# SERVICE BULLETIN

Classification: EC17-035	Reference: NTB18-018	Date: March 1, 2018
-----------------------------	-------------------------	------------------------

## 2013-2015 ALTIMA; ROUGH IDLE ON START UP

**APPLIED VEHICLES:** 2013-2015 Altima (L33)

Figure A

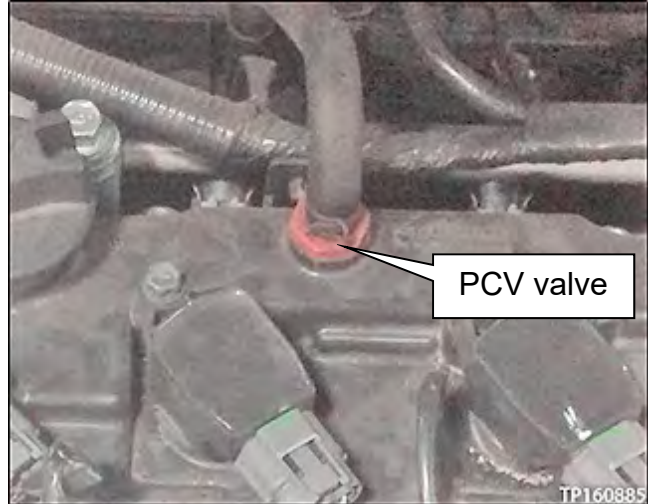
2. If the PCV valve is **orange** in color, replace it.

**NOTE:** The new PCV valve is **black** in color.

3. If the vehicle's PCV valve is already **black** in color, do not replace it.

- See **PARTS INFORMATION**.
- Refer to the Electronic Service Manual (ESM), section **EC-Engine Control System**, for PCV valve replacement information.
